# Reliability Analysis Update PJM West

Jin Liang Han  
Sub Regional RTEP Committee – PJM West

# Scope Change

**B4003.5:** part of 2025-W1-156, Presented in 11/04/2025 TEAC

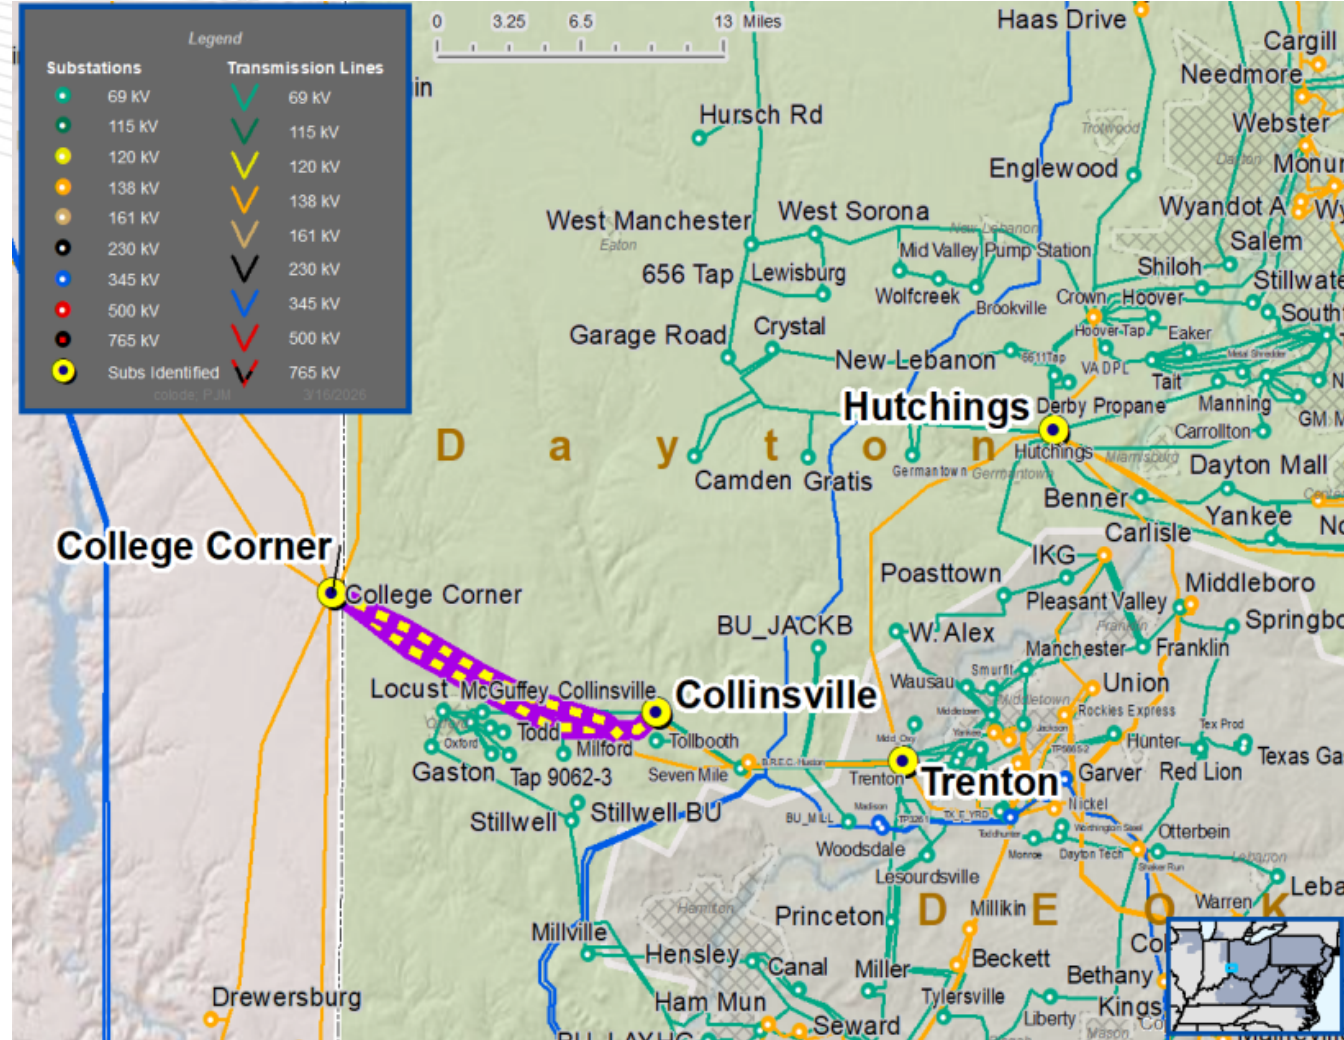
After further analysis, DEOK's & Dayton's engineering team confirmed that relay settings will need to be updated at Dayton's Hutchings substation instead of DEOK's Trenton substation to reflect the new impedance for the partial College Corner – Trenton rebuild.

**B4003.5:** Update relay settings at Trenton 138 kV Substation (b4003.5)

**B4003.6:** Update relay settings at Dayton's Hutchings 138 kV Substation (b4003.6)
